STATE OF NORTH CAROLINA
DEPARTMENT OF TRANSPORTATION

SUBJECT: Permit Modification Request for TIP No. R-2809B and C, Wake County, NC DOT Division 5, Federal Aid No. STP-98(1), State Project No. 8.1402501, USACE Action ID 199601836, and DWQ Project No. 010550, \$475 Debit Work Order WBS Element 34503.1.1

R-2809, Wake Forest Bypass, Wake County

SHEET 17 OF 26

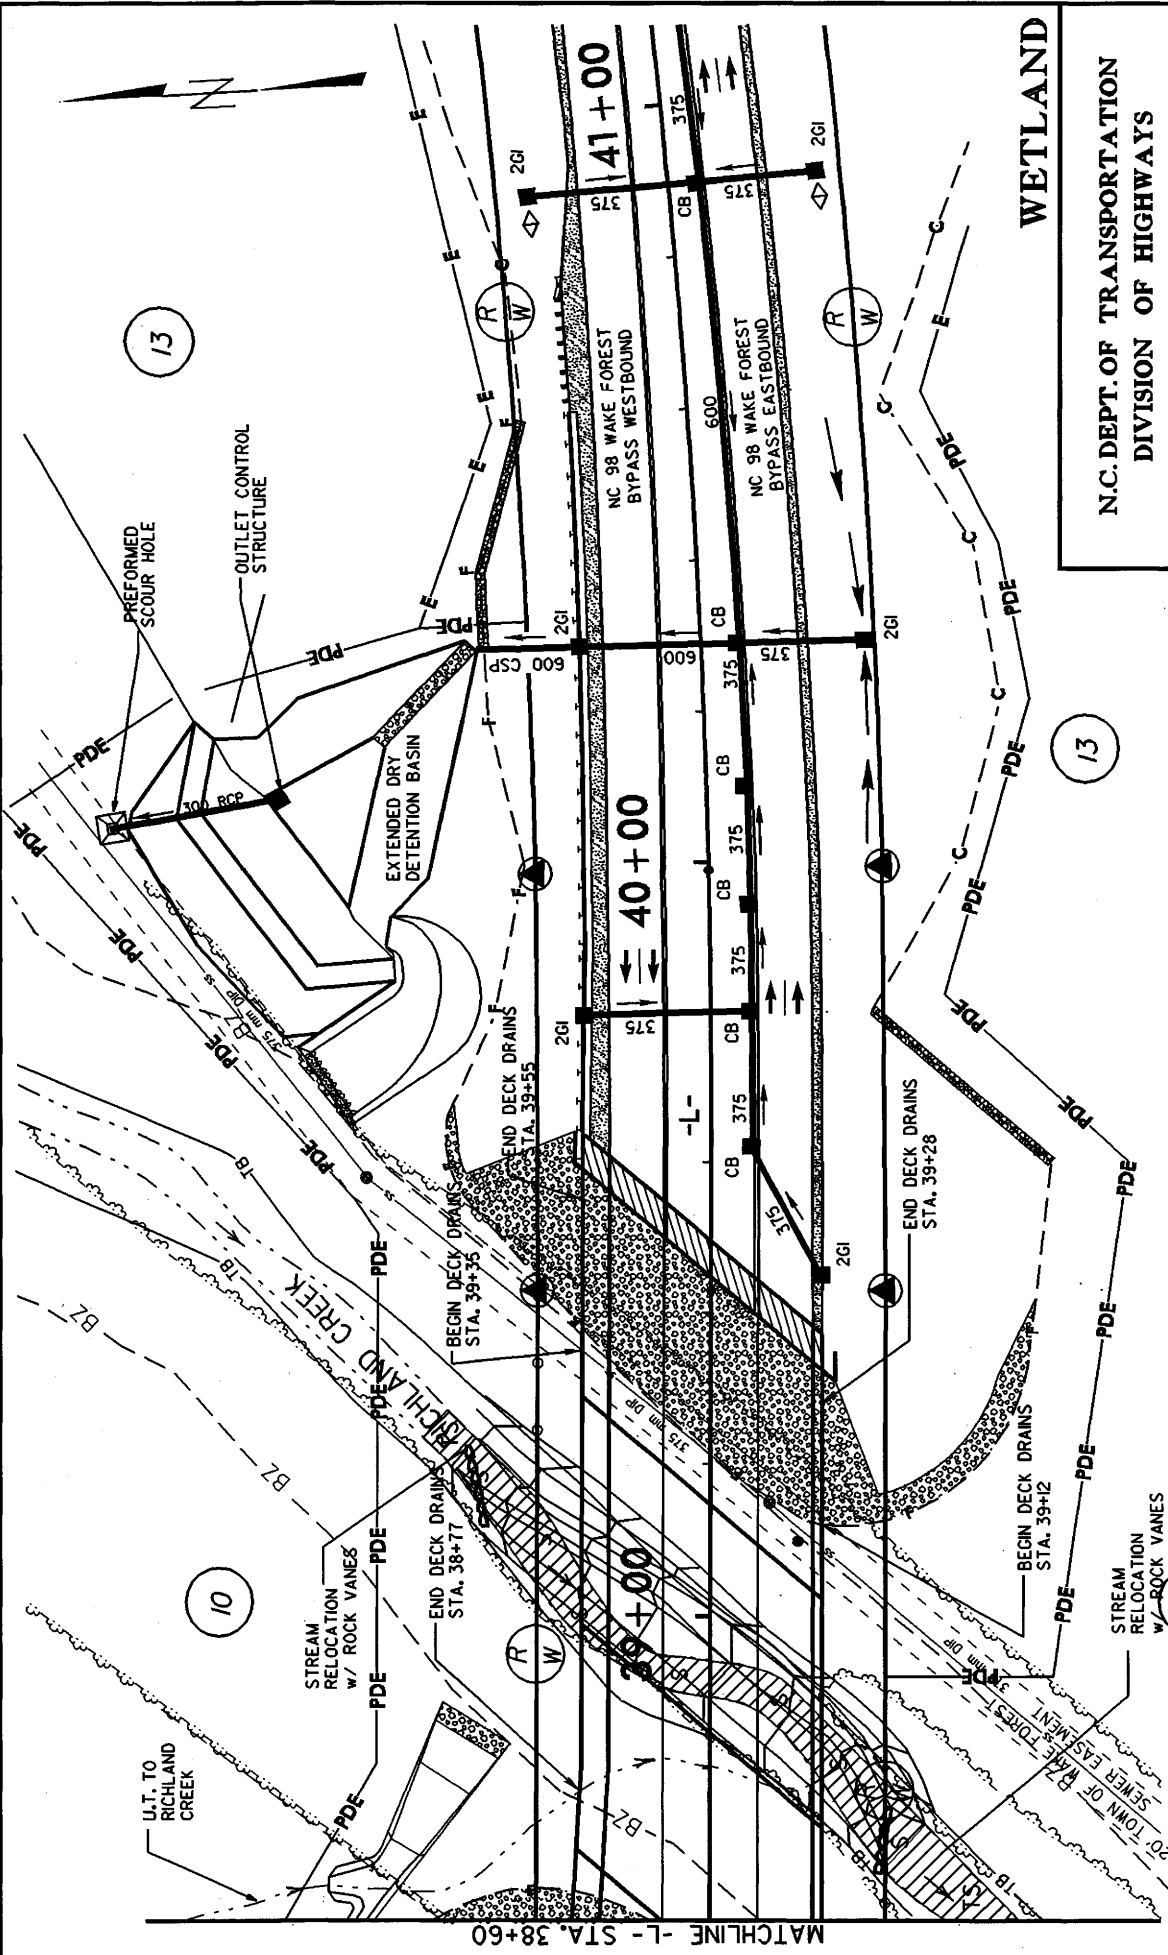
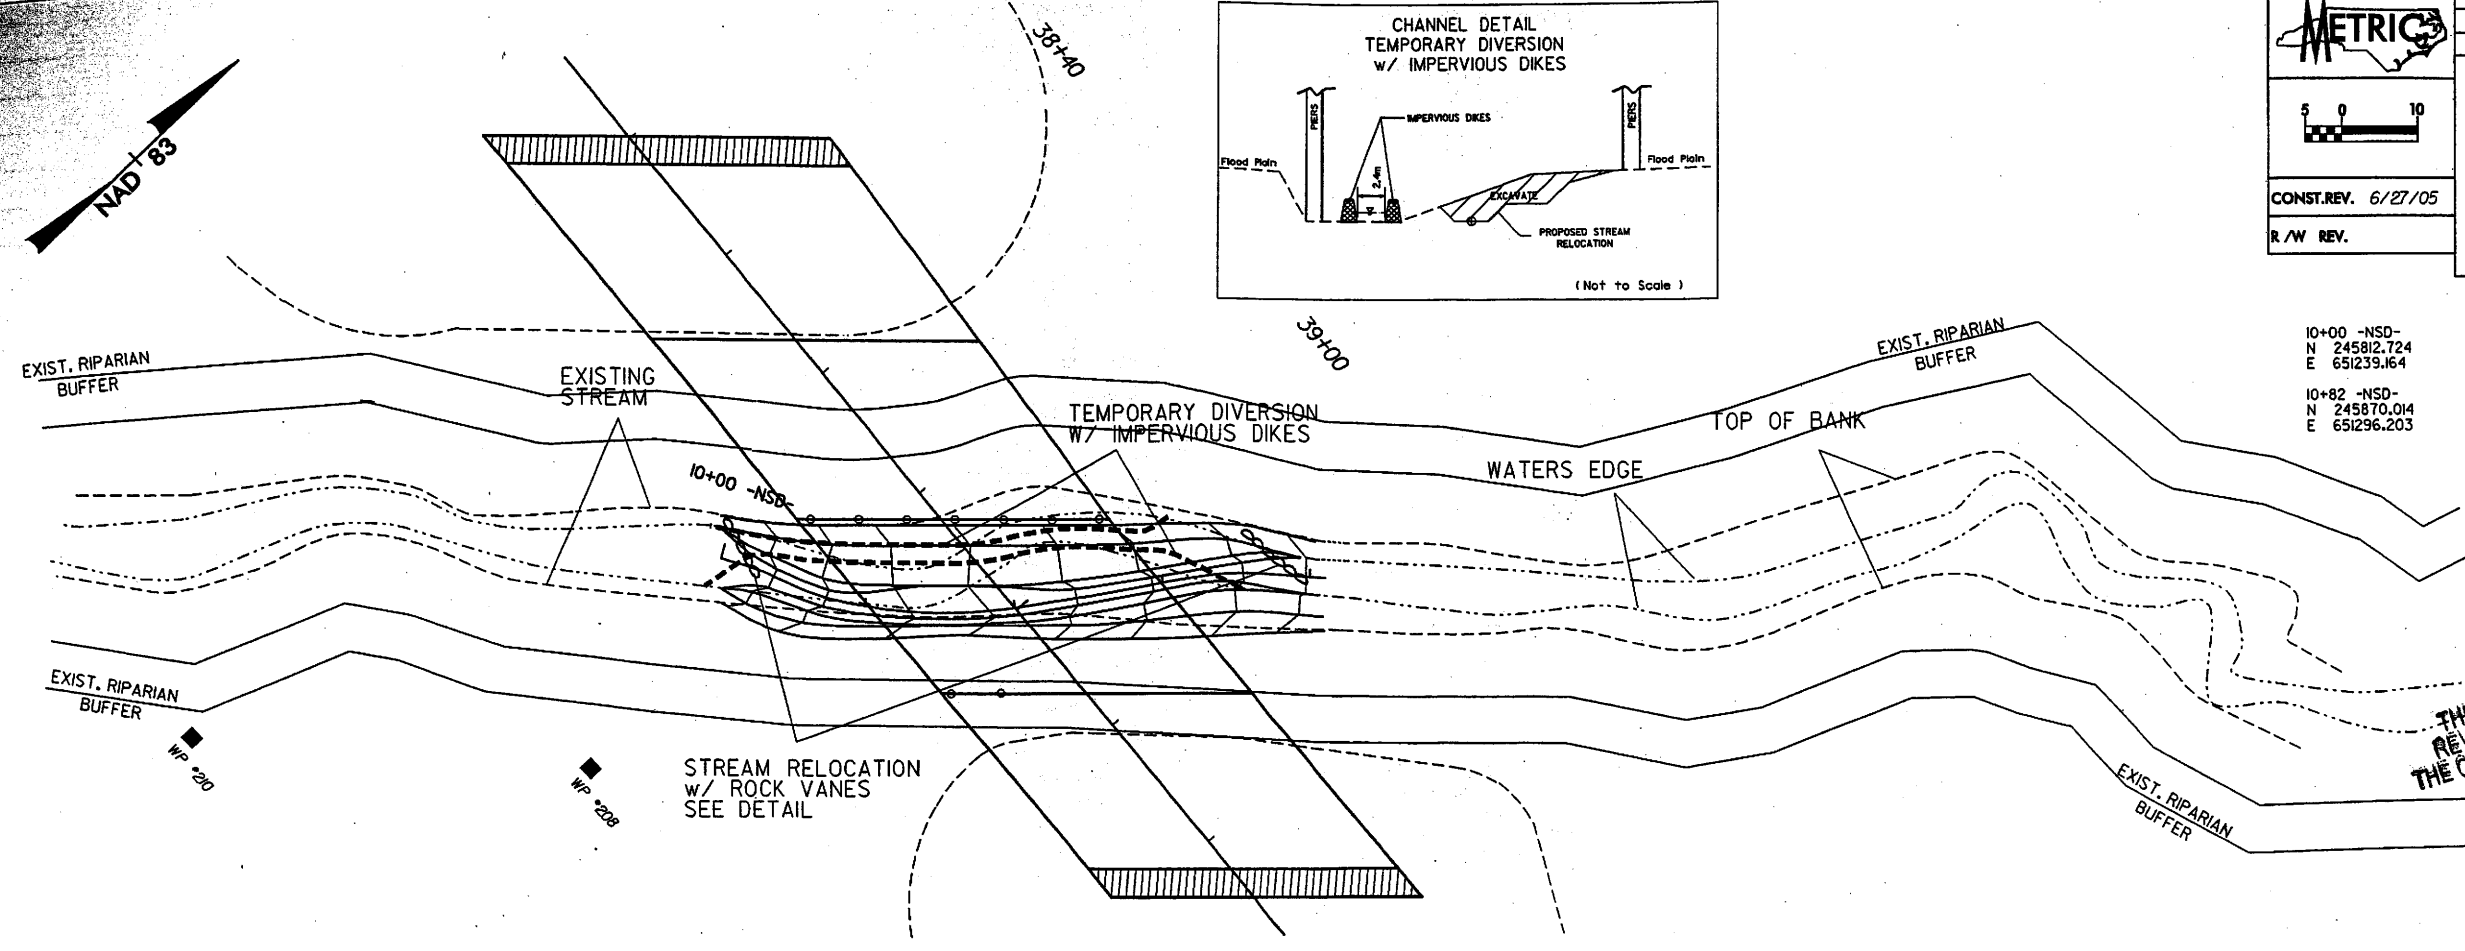
R-2809B Site 4, Sheets 17 and 18 of 26

Station -L-38+84

Plans for the prior approved relocation of Richland Creek using natural channel design have been revised so that a smaller portion of the channel will be impacted. The only portion of Richland Creek that will be relocated using natural channel design will be the portion adjacent to the bridge bent number 2. Revised plan view and cross sections have

been included with the permit drawings showing the revised stream relocation.

**Impact change: Decrease of 82 feet of Permanent Stream Impacts
Decrease of 82 feet of Natural Stream Design**

SHEET **5** OF **12** REVISED 5 / 05

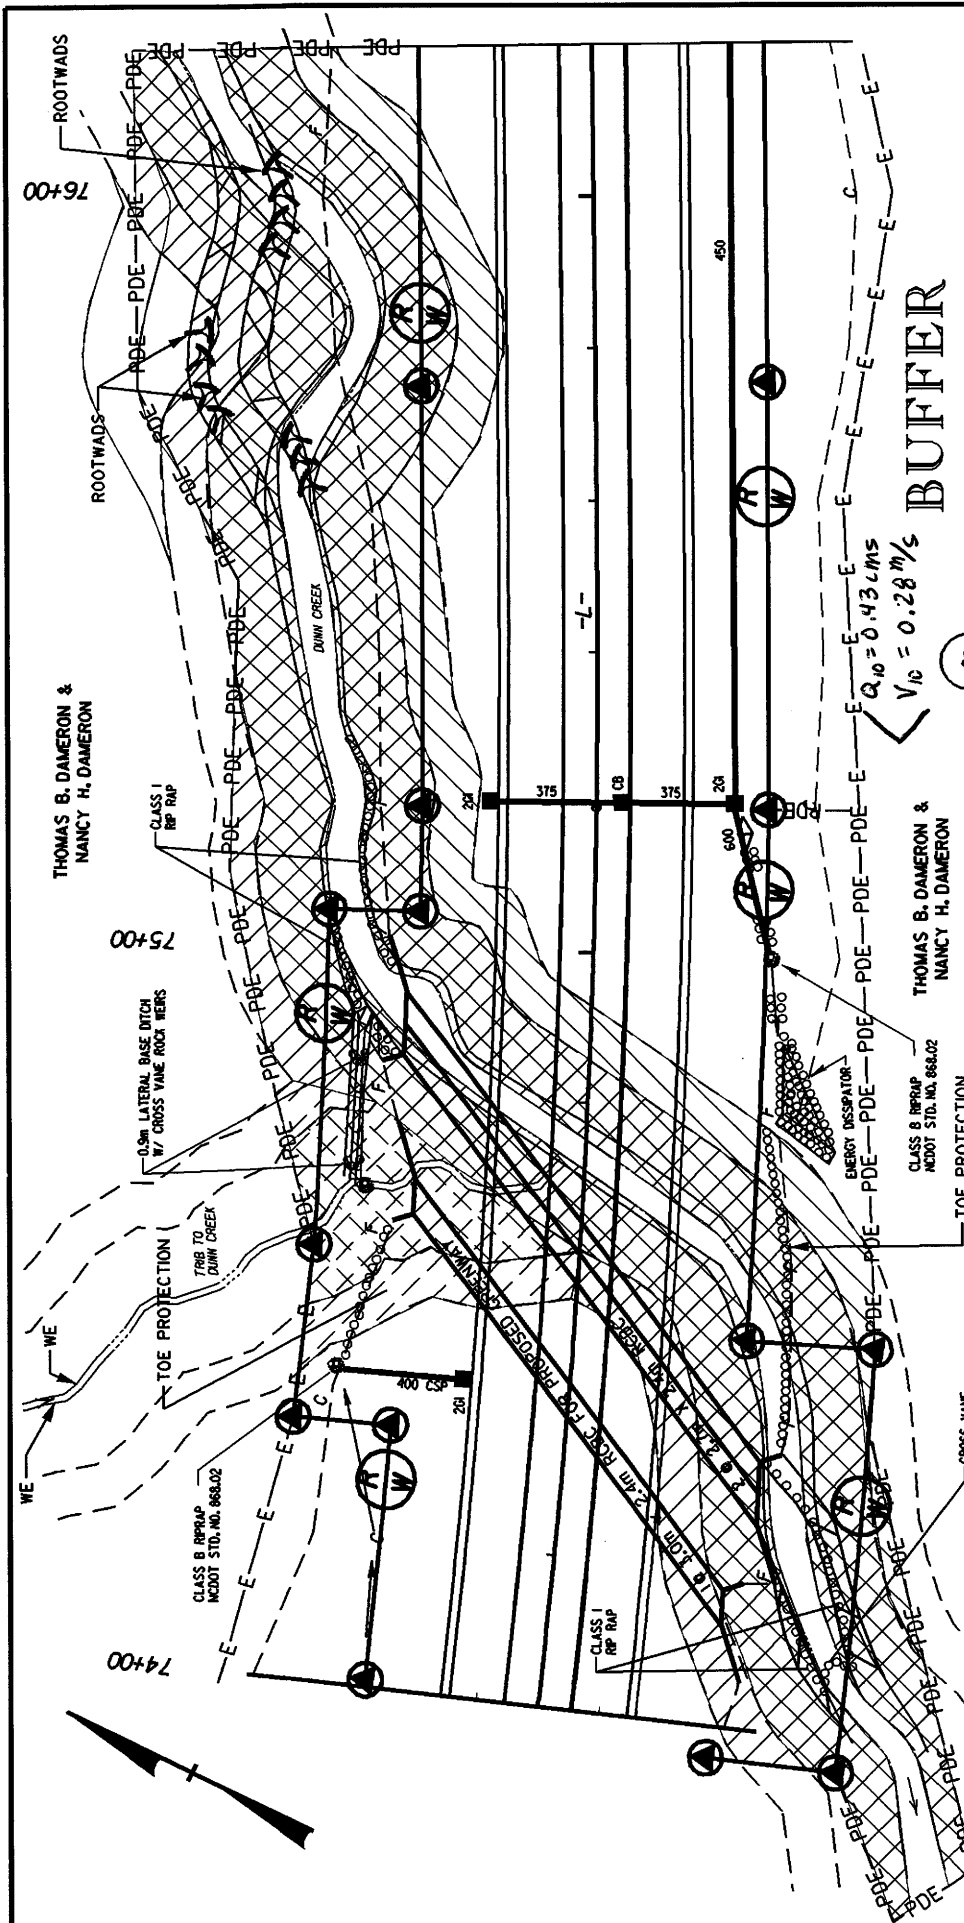
R-2809C Site 2, Sheet 5 of 12

Station -L-66+40

The impacts at this site have increased due to stream bank grading at culvert inlet. No mitigation is proposed because impacts are temporary

Impact change: Increase of 53 feet of Temporary Stream Impacts

SHEET 7 OF 12 REVISED 5/05

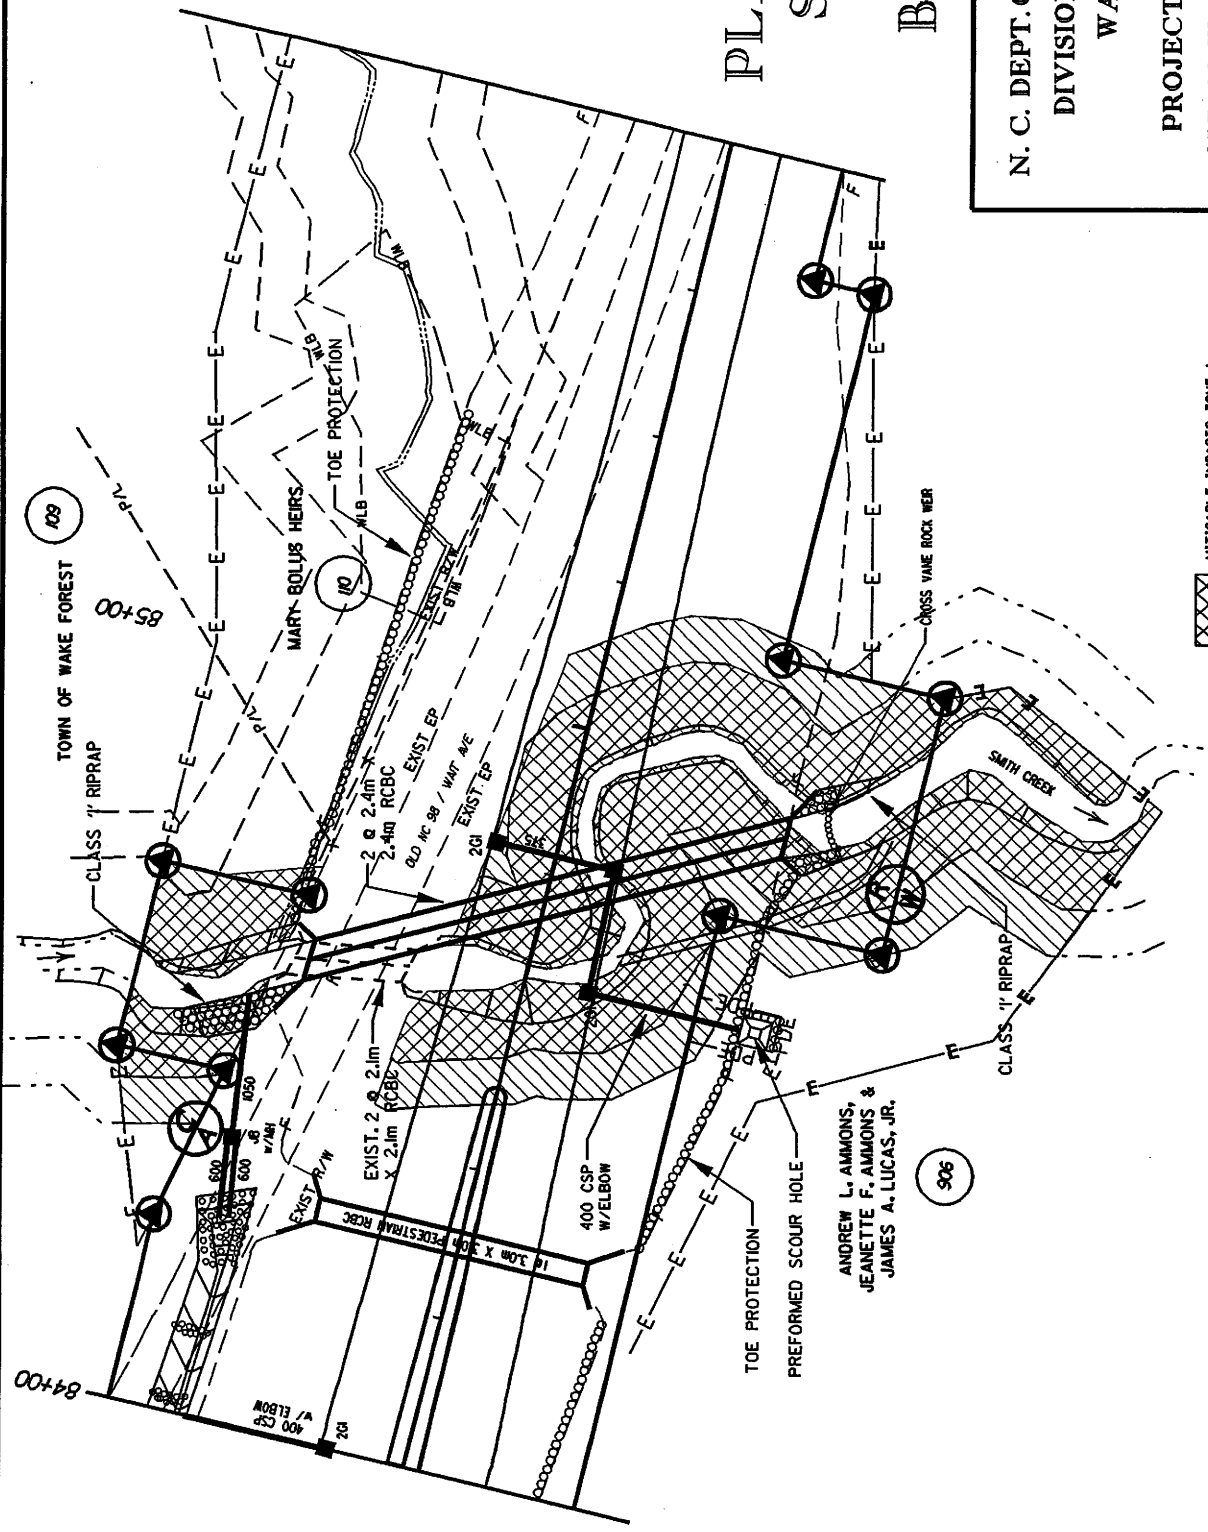
R-2809C Site 4, Sheet 7 of 12

Station -L-84+60

Additional area for construction access was needed at this site to re-grade the stream banks and to install the rip rap along the banks.

Impact change: Increase of 3,819ft² of Mitigable Buffer Impacts.

PROJECT: 8.1(02504 (R-2809C)
NC 98, WAKE FOREST BYPASS
FROM WEST OF US 1A
TO EAST OF SR 2053
SHEET 6 OF 12 REVISED 5 / 05

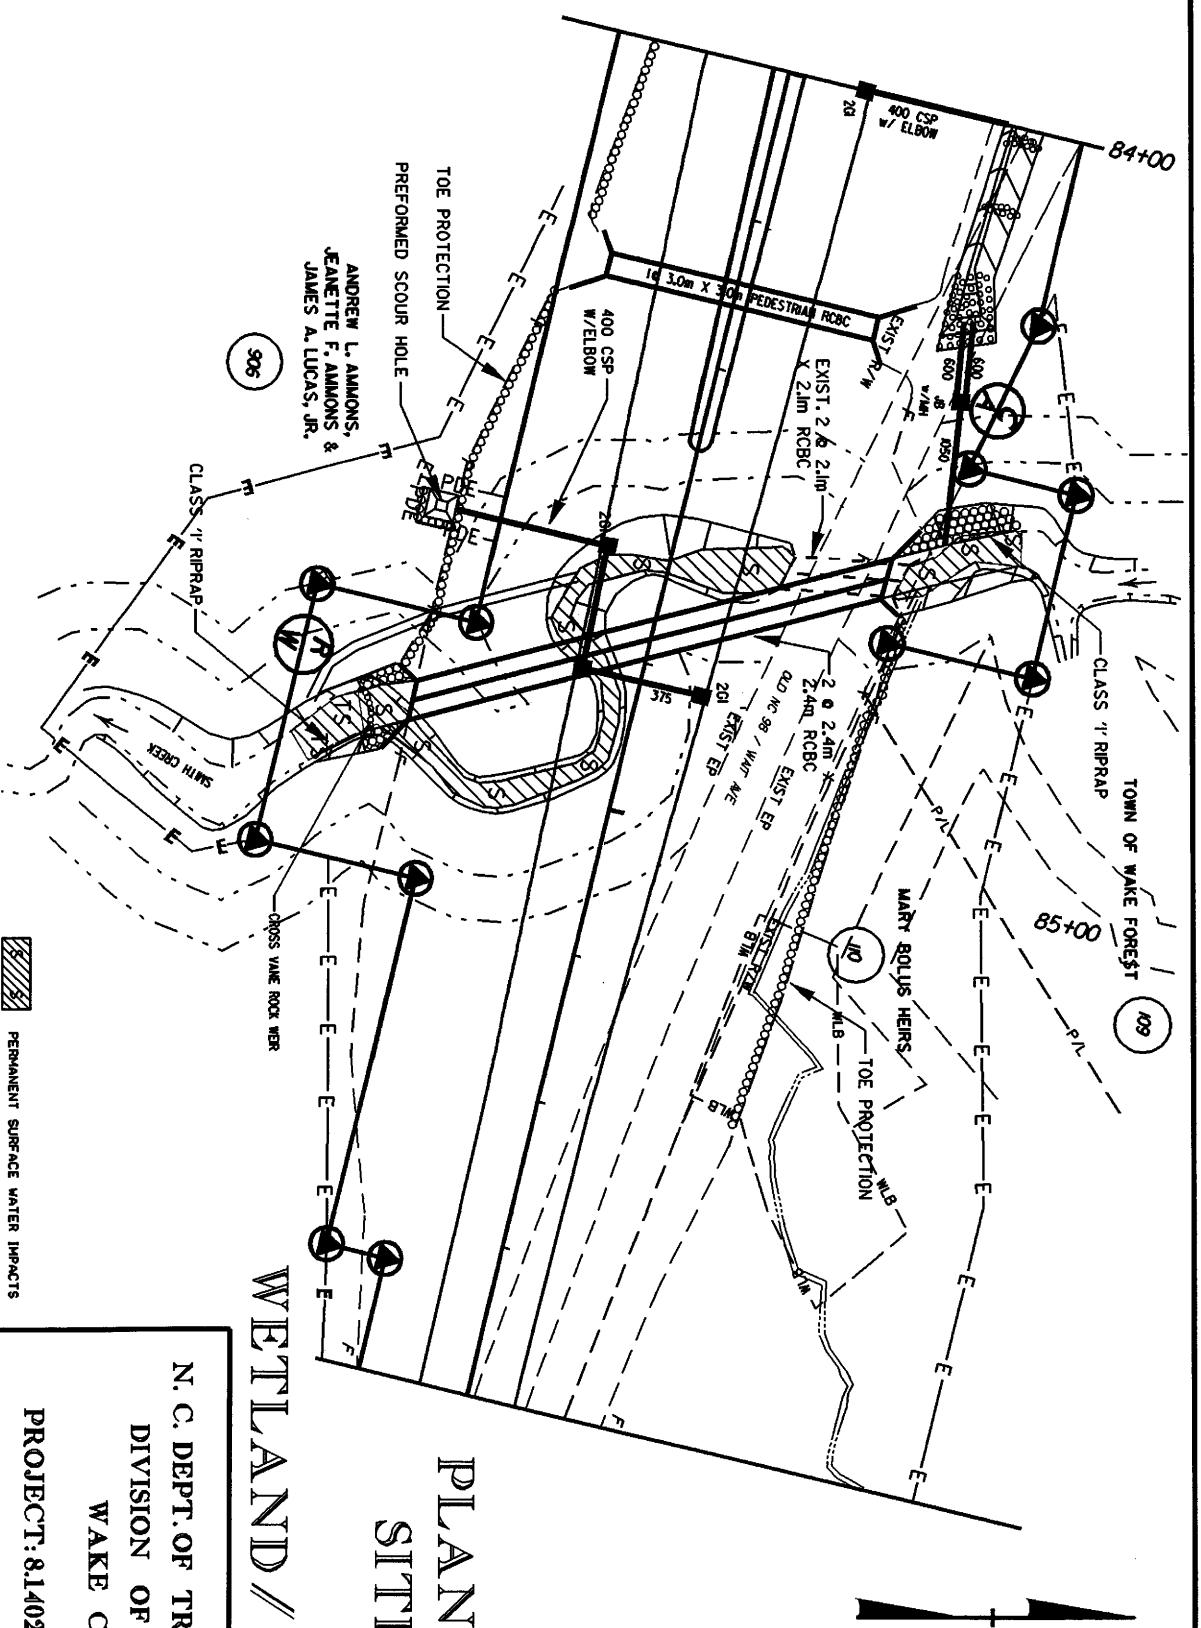
R-2809C Site 3B, Sheet 6 of 12

Station -L-74+20 / 76+20

The bank at the culvert inlet and outlet was re-graded so the fill from the roadway could tie into the natural elevation of the stream bank. Rip rap was also installed on 95 feet of the bank for bank stability where the bank was re-graded

Impact change: Increase of 105 feet of Permanent Stream Impacts

Increase of 53 feet of Temporary Stream Impacts

Decrease of 14 feet of channel relocation using natural channel design

R-2809C Site 3B, Sheet 6 of 12

Station -L-74+20 / 76+20

The bank at the culvert inlet and outlet was re-graded to the construction easement so the fill from the roadway could tie into the natural elevation of the stream bank. Rip rap was also installed for bank stability where the bank was re-graded

Impact change: Increase of 6,835ft² of Mitigable Buffer Impacts.
